Bid Addendum No. 3

September 23, 2026
Washingtonville Central School District – 2024 Capital Project - Phase 3
CSArch Project No. 228-2401.03
SED Control No. Varies

This Bid Addendum No. 3 forms part of the Contract Documents and modifies the original bidding documents dated August 31, 2026. Bid Addendum No. 3 consists of (6) Cover Pages, (4) Specification Sections, (16) 30x42" Drawing Sheets, and Responses to Bidder Requests For Information.

Sheet No.
WMS C120

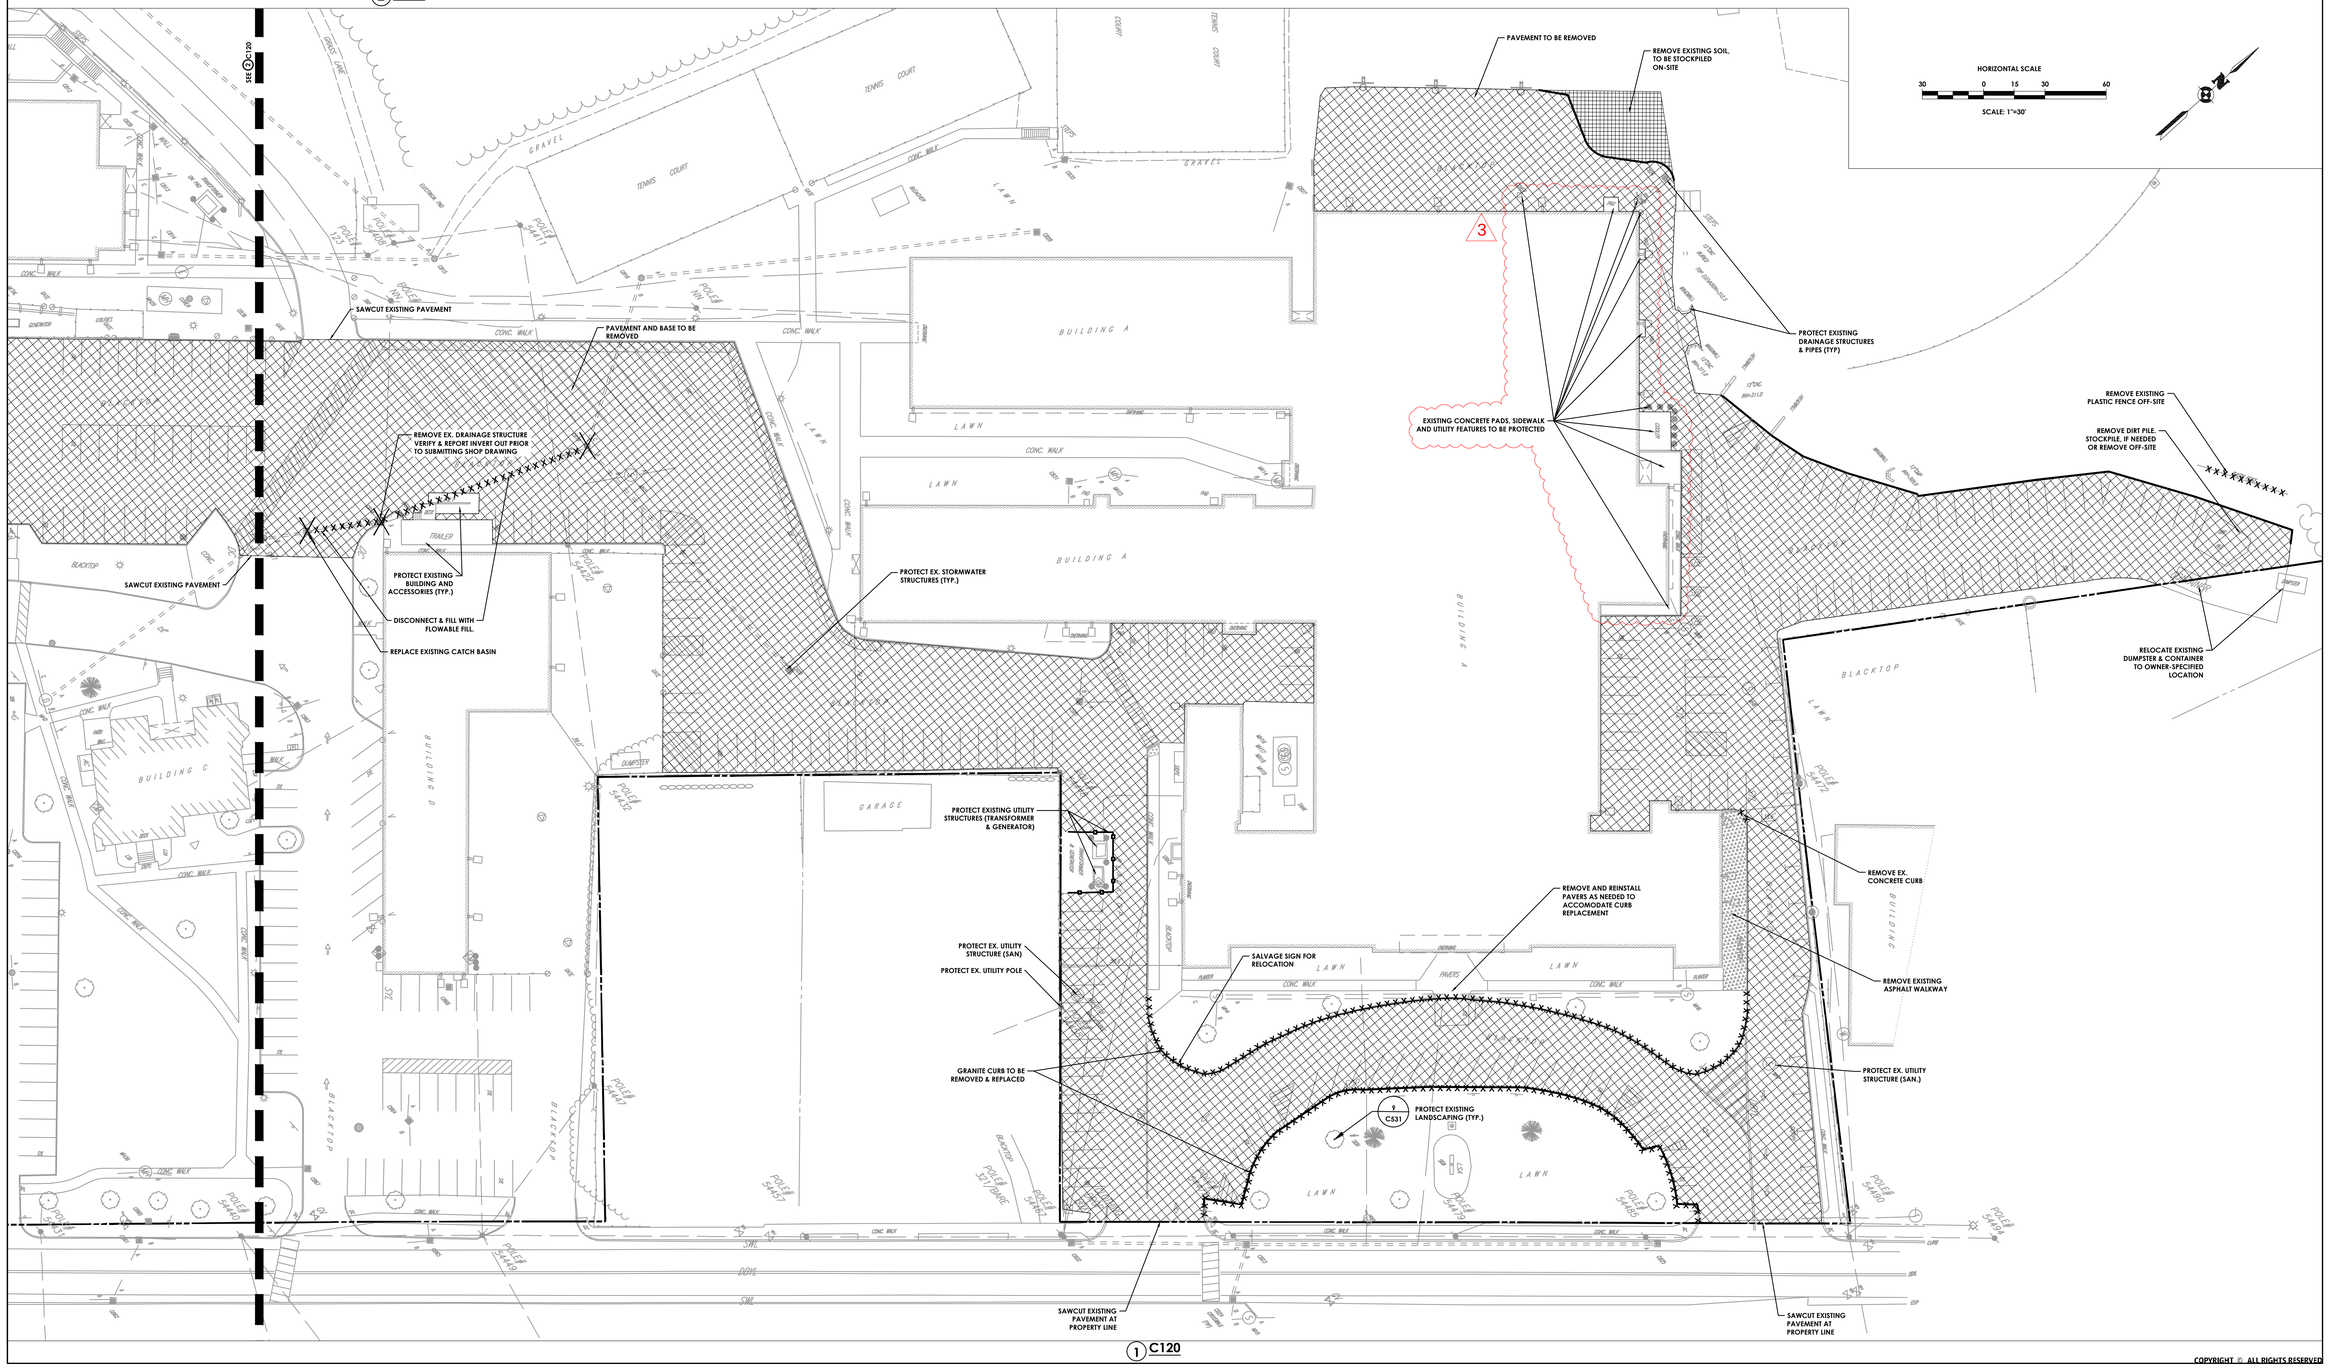
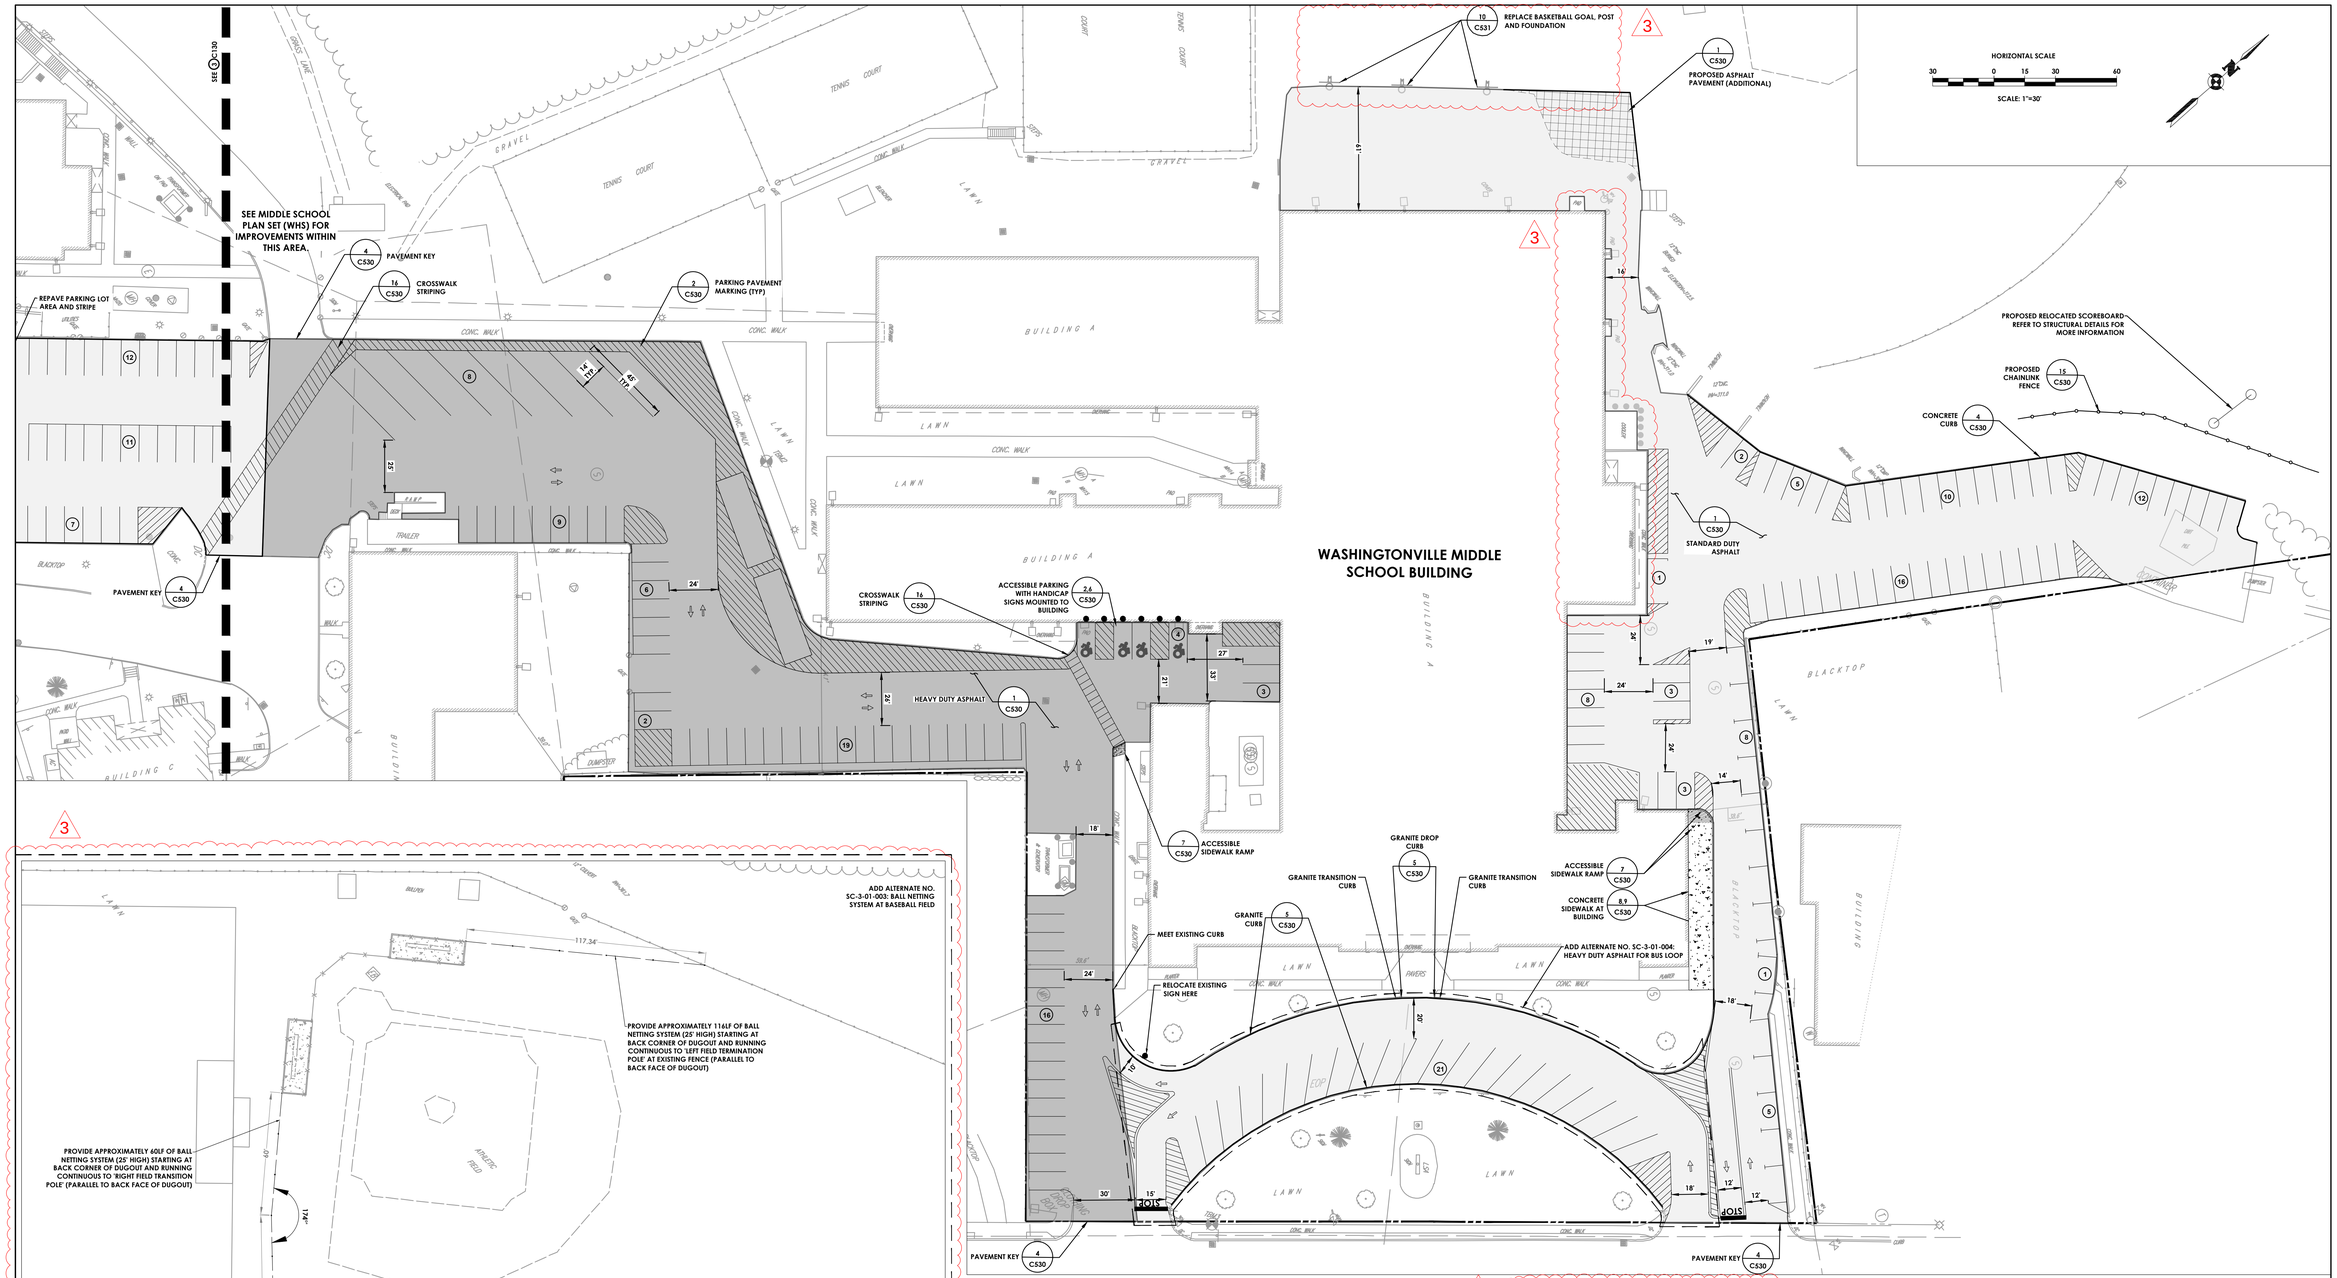
9. Demolition Plan C120 - In the hatched area depicting demolition at the northern wall of the building, there is a cooler, concrete sidewalk, concrete curb, bollards & a door pad. Are these items to be demolished, removed & replaced or are they to remain & be protected?

a. Response: *Work has been clarified/revised and has been included in updated drawing sheets issued as part of this Bid Addendum #3.*

2 BASEBALL FIELD SITE IMPROVEMENTS

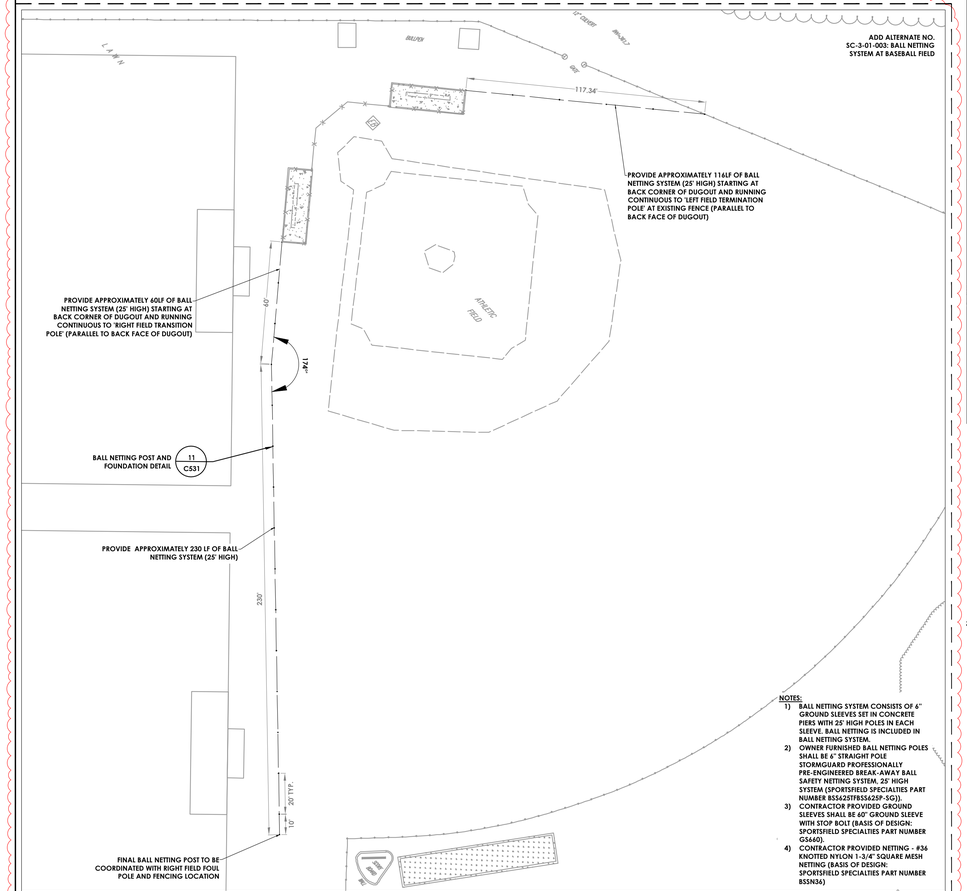
8. The Ball Netting System for the Baseball Field is not specified. Pole diameters, overall height and foundation details do not appear to be indicated in any of the drawings as far as I can tell. Please clarify.

a. Response: *Refer to revised detail 2 on drawing sheet WMS C130 issued in this Bid Addendum #3 for additional information on ball netting systems.*

10 BASKETBALL POLE AND FOUNDATION
N.T.S.

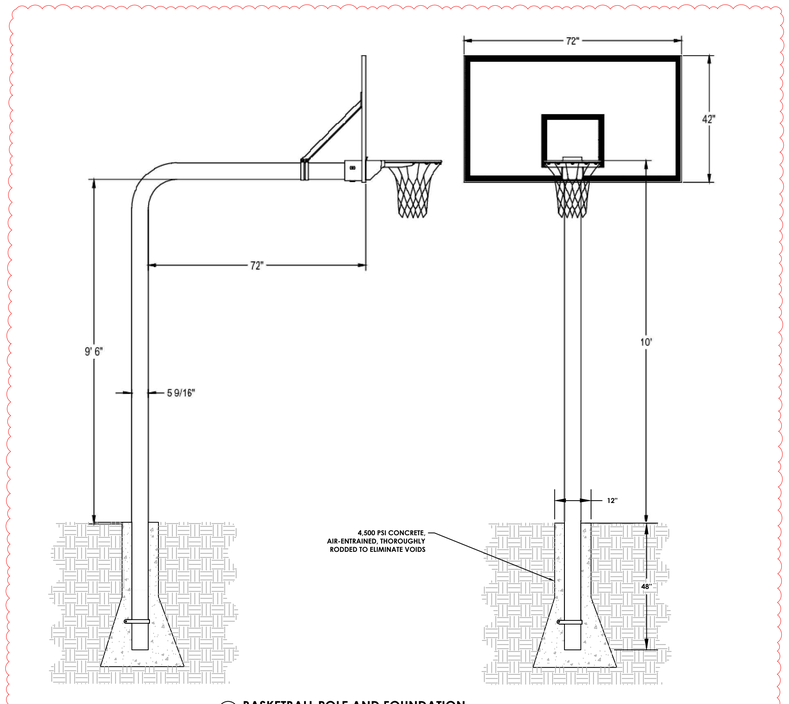
4. Sheet WMS C130 - Provide model number and foundation detail for the three (3) basketball goal posts to be replaced.

13. Site Plan C130 - There are 3 basketball goals, posts & foundations noted to be replaced at the edge of the parking lot, but there isn't a detail or information in the specifications for new ones. Is the intent to re-use the existing goals & posts, or are new ones required?

a. Response: *Additional information on basketball goal post has been included in updated drawing sheets issued as part of this Bid Addendum #3.*

a. Response: *Additional information on basketball goal post has been included in updated drawing sheets issued as part of this Bid Addendum #3.*

2 ENLARGED KITCHEN PLAN

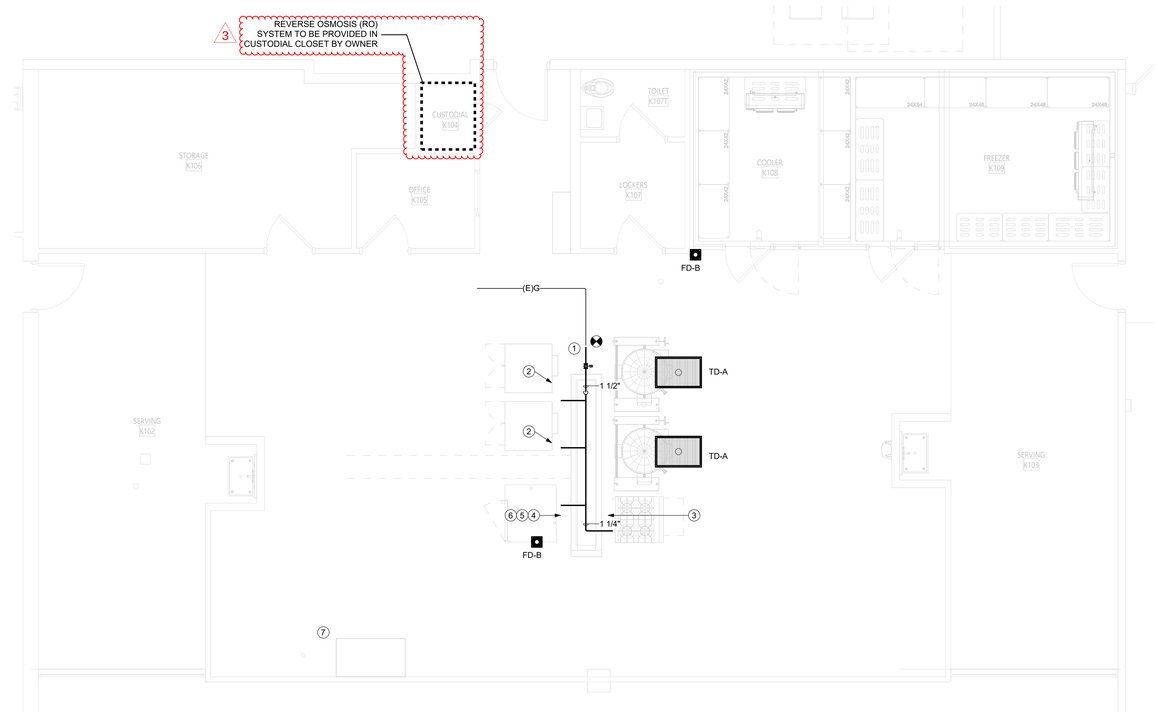
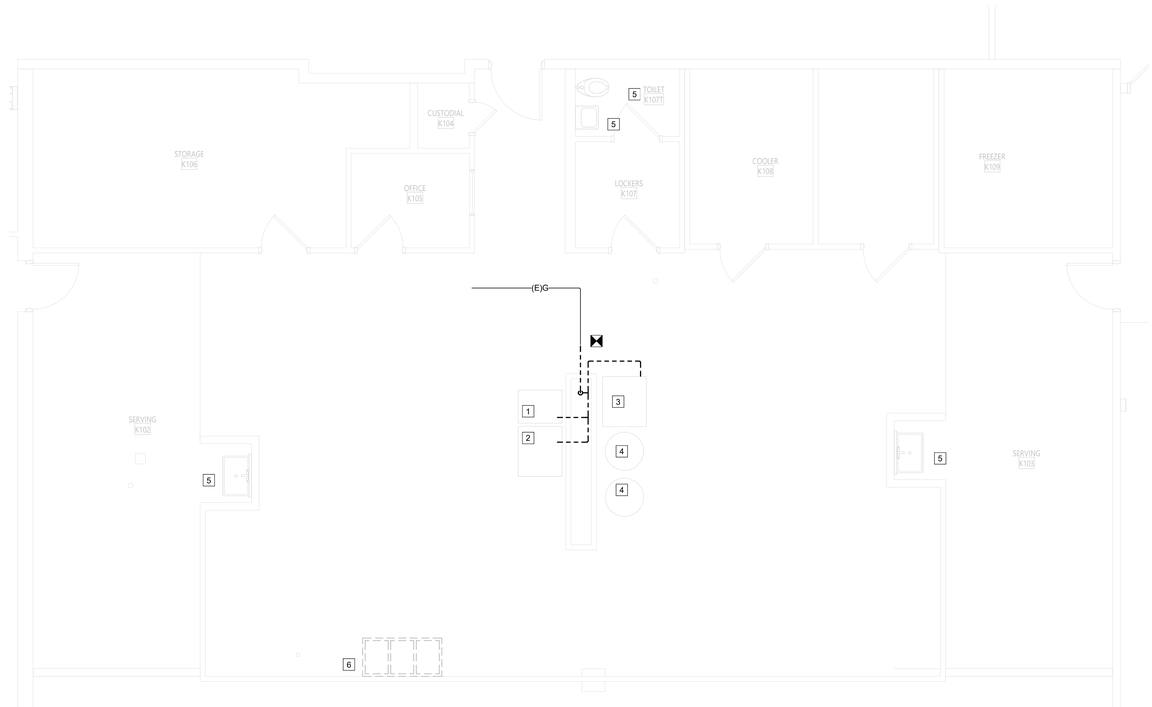
14. WMS P611 - Note 3 doesn't exist. The rest of notes explain size of water lines connecting stoves, but where's the reverse osmosis lines? Where is the custodial closet? Where's the filtered water lines? Theres nothing on drawing, so I can get distance or an accurate idea of how many 90s are required to provide a proper takeoff. It would be good if we could see the water and waste lines, not just the gas lines.

a. Response: *Refer to revisions to drawing sheet WMS P611 issued with this Bid Addendum #3.*

14 SEATING WALL STAIRS

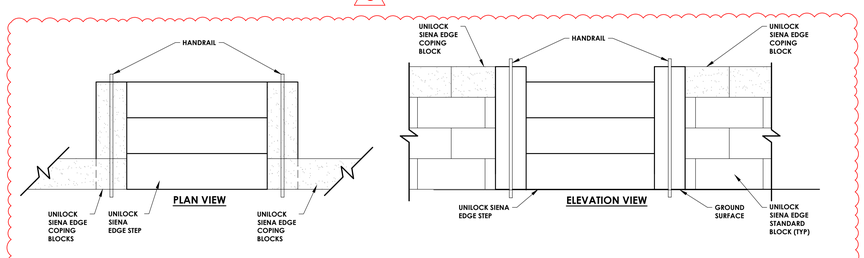
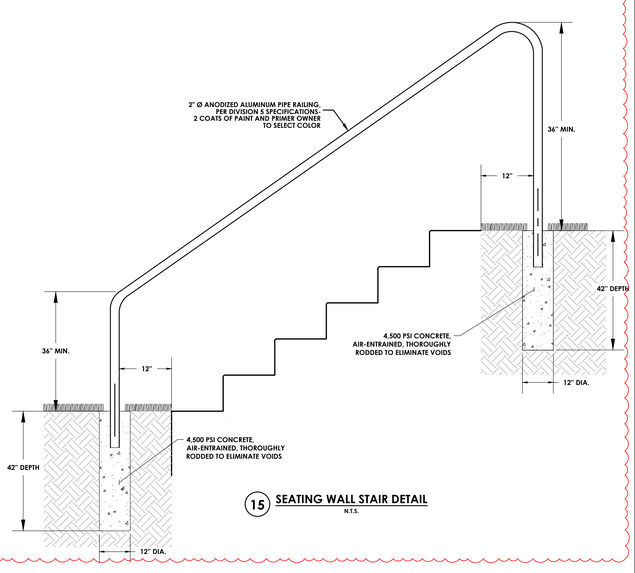
11. Seat Wall Details C531 - The handrail indicated in the details & in Note # 2 state that the proposed handrail is to be attached to the "Sienna Edge Blocks". The attaching method shown in the detail does not match the existing handrail & seat walls on site. It also shows the handrail ends attached to the return walls which is not possible with the design & the proposed elevations indicated (The top of the wall is at ground level.) Can a clarification to the railing design be provided?

a. Response: *Refer to revised detail 14 and new detail 15 on drawing sheet WHS C531 issued in this Bid Addendum #3 for additional information on railing systems for the seating walls.*
